**CITY OF
BLOOMINGTON**
HOUSING AND NEIGHBORHOOD DEVELOPMENT

BHPC MEETING PACKET

Thursday January 23, 2025

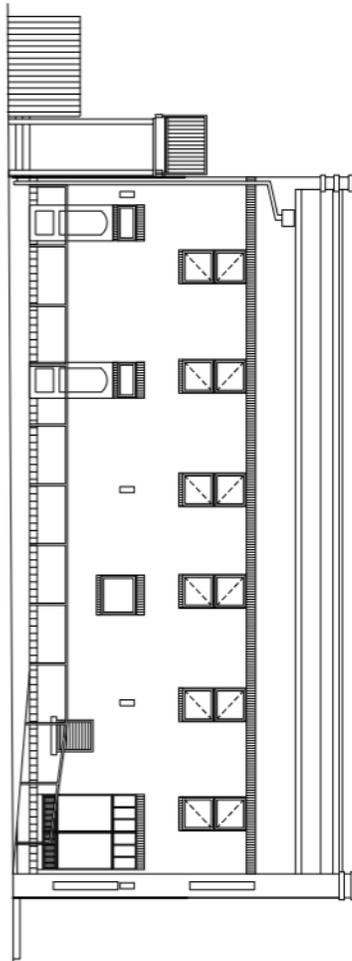
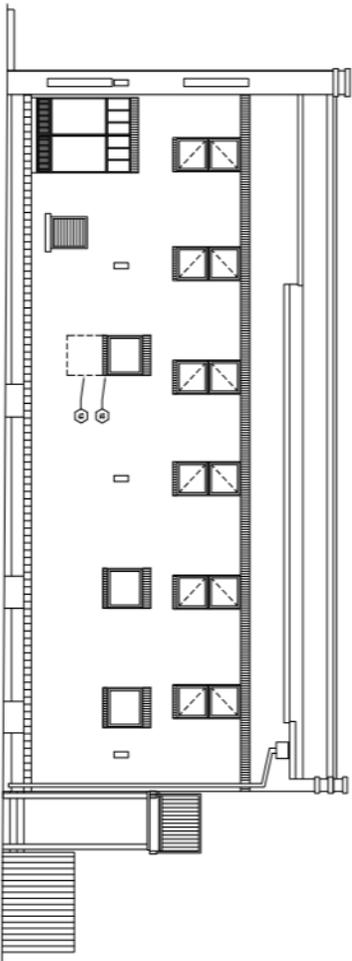
Staff recommends approval of COA 25-03

The proposed alterations would not disrupt the building's existing fenestration pattern, and the proposed replacement windows would match existing replacement windows on the building. The replacement of an unoriginal door as required for code compliance would not entail the removal of historic materials or a significant change in the building's features.

20 West Elevation:

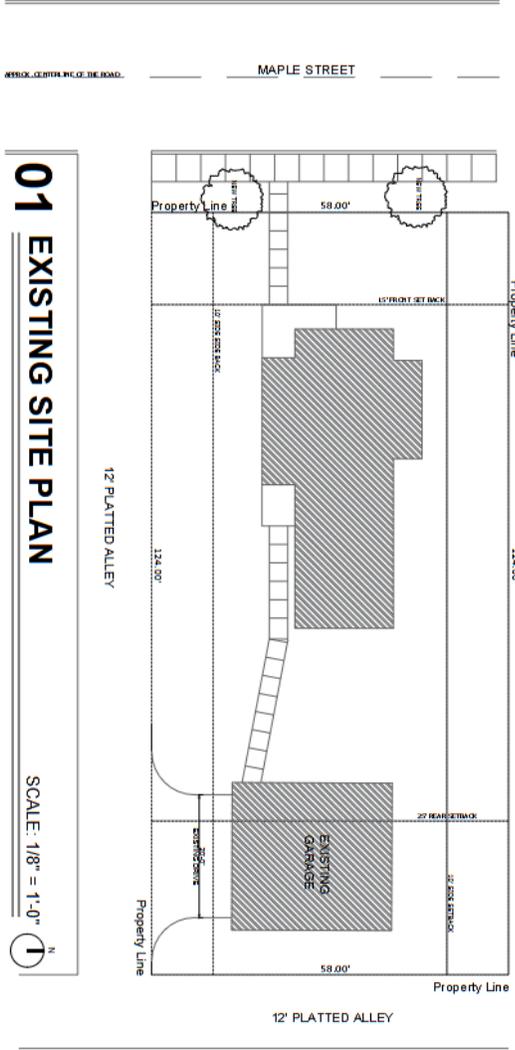
The petitioner told us by email on 1-14-2025 that there would be no stone on the façade, that this was an error, and that he was planning to use horizontal siding (and, at

the top, wooden shake siding). We concur that we prefer horizontal siding, not stone. However, the current plan indicates “horizontal vinyl siding”: at our December 11, 2024 meeting with the petitioner, he had said the siding would likely be fiber cement, which we prefer for new construction

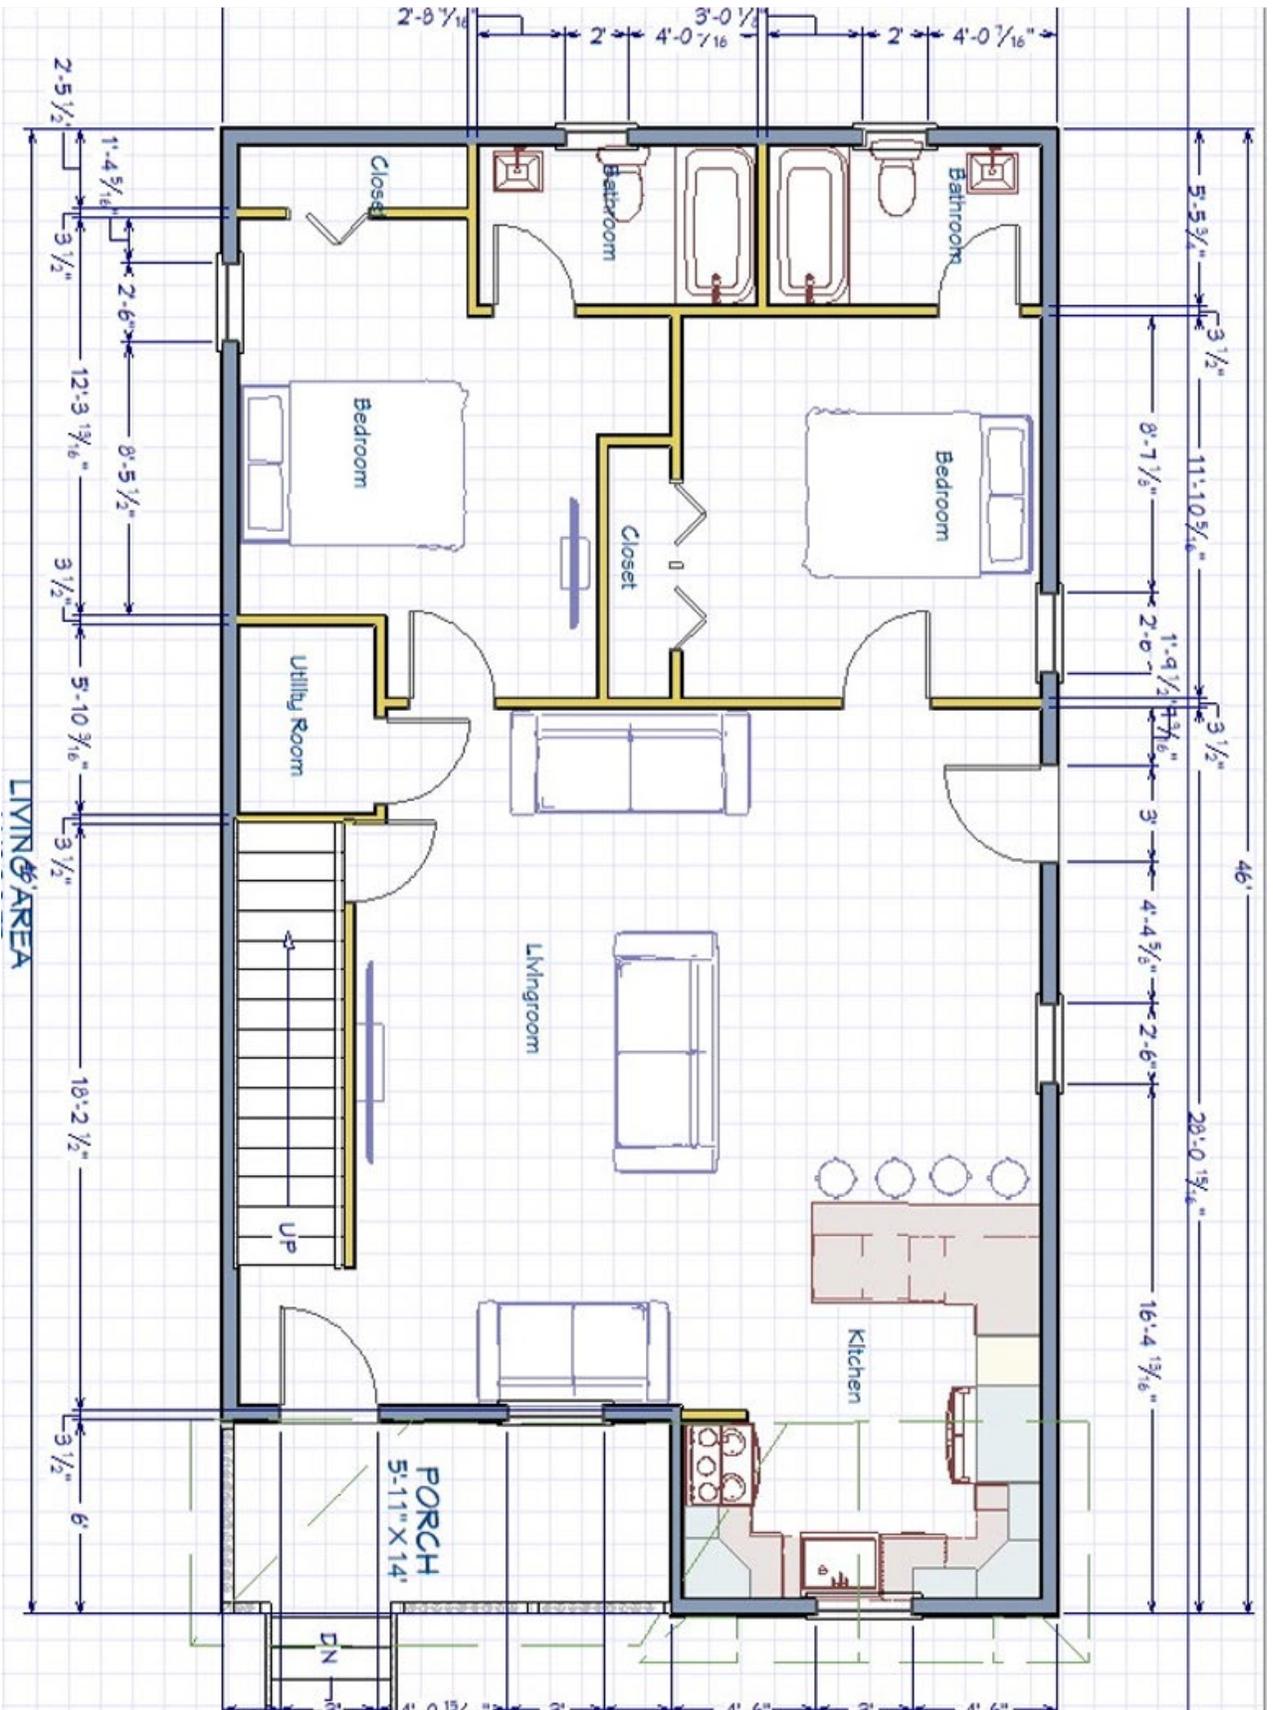
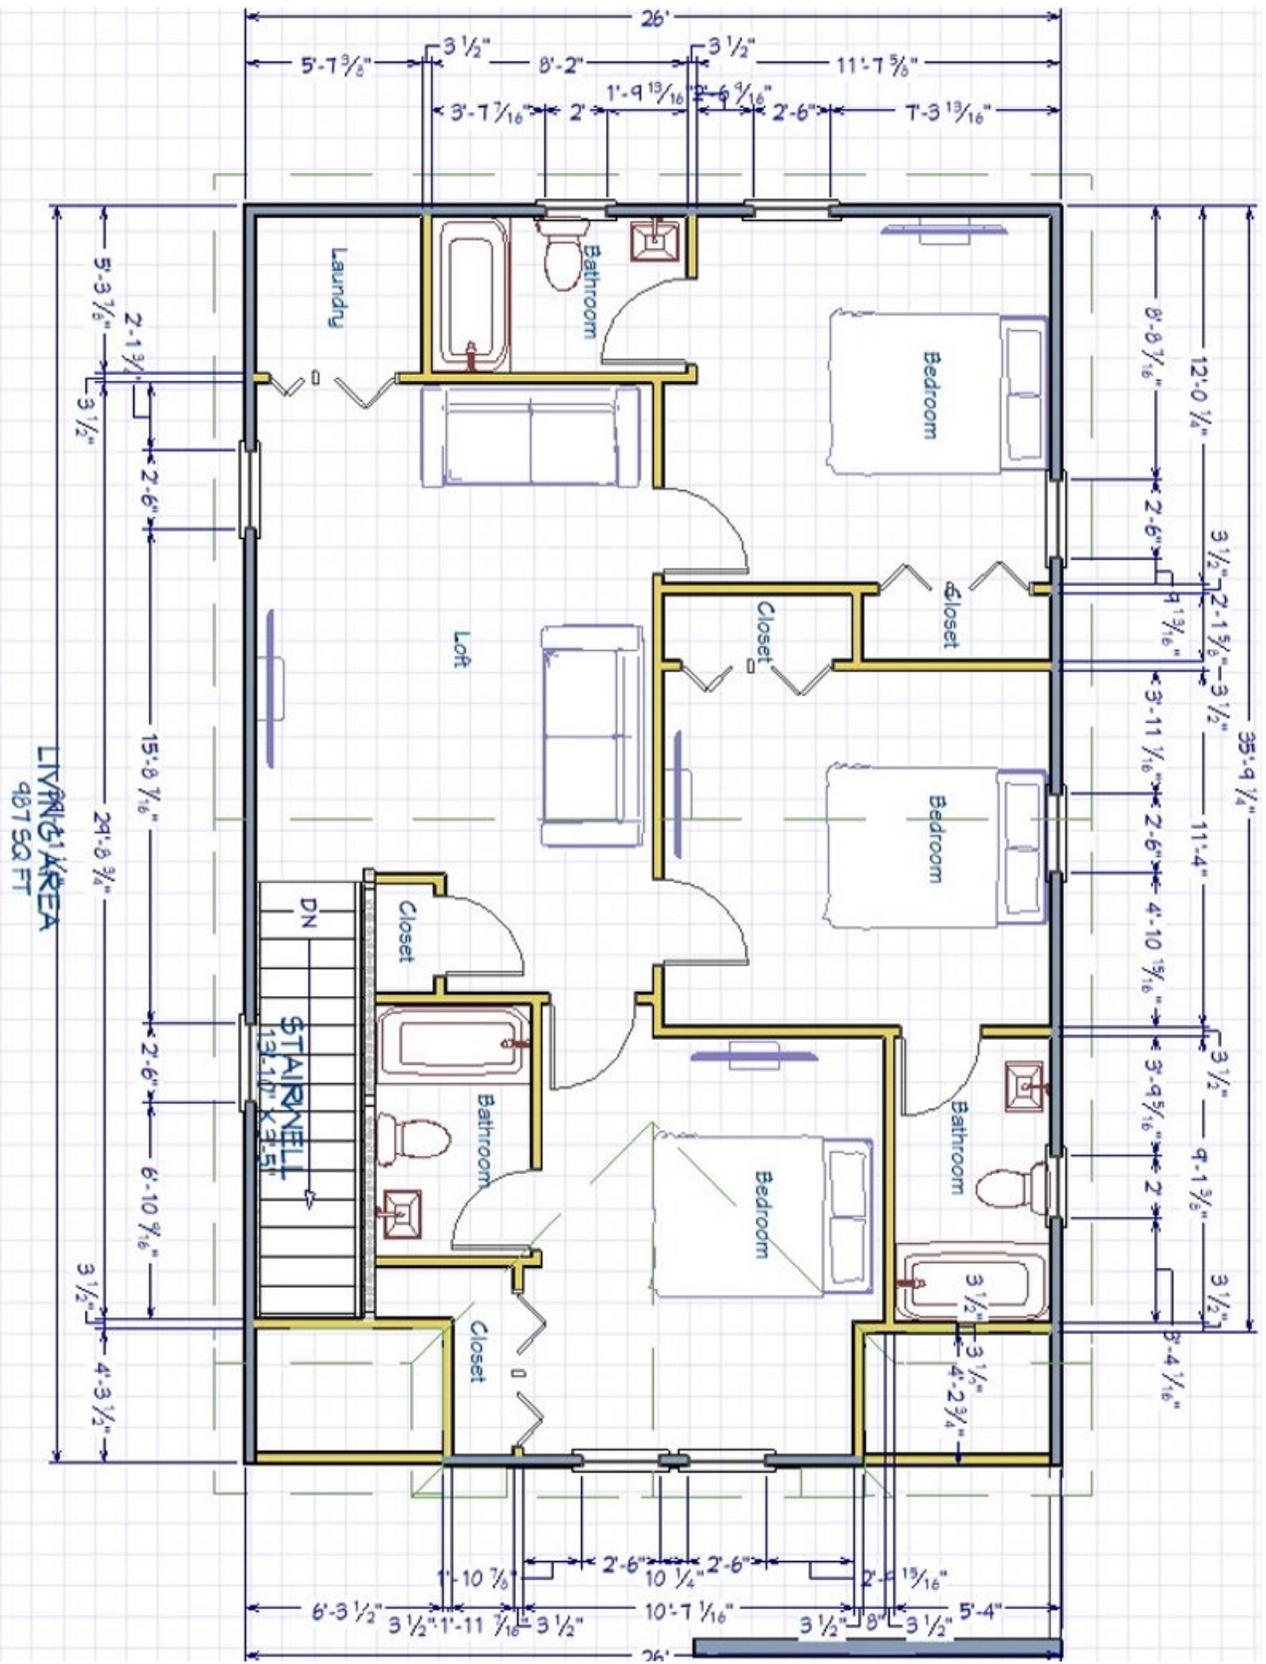
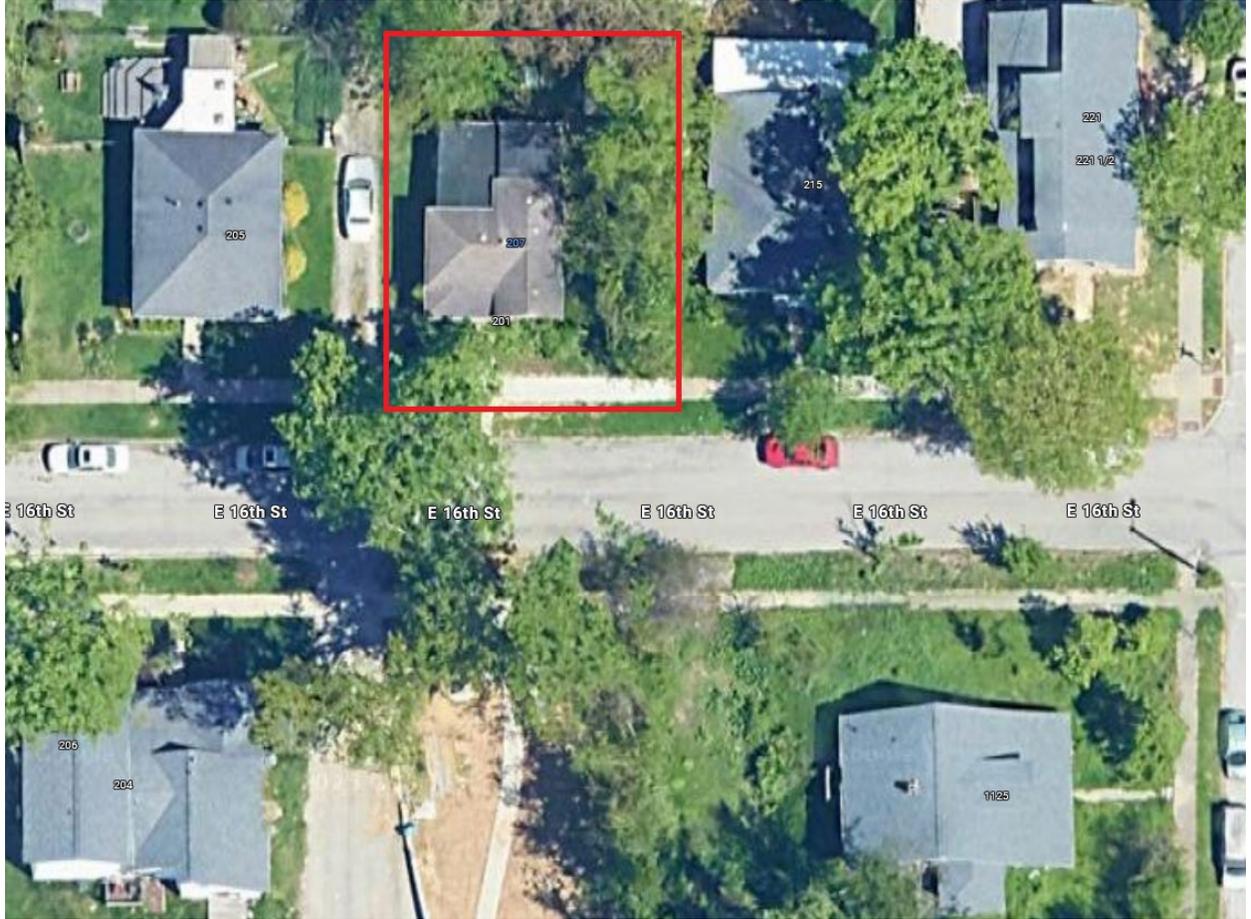
Staff does not recommend approval of COA 25-07

Changes proposed to the front elevation include the removal of the door on the el, a defining characteristic of this style of house, as well as the removal of a window on the west elevation near the front of the house. The combined effect of these alterations would have a significant impact on the proportion of openings for the public way façade.

The alteration to the rear addition and expansion toward the north elevation would not have an oversized impact on the property, and neighboring houses across the block are two-stories tall. Because of the roofline's distinctive shape, care should be taken to design an addition that leaves this shape intact.
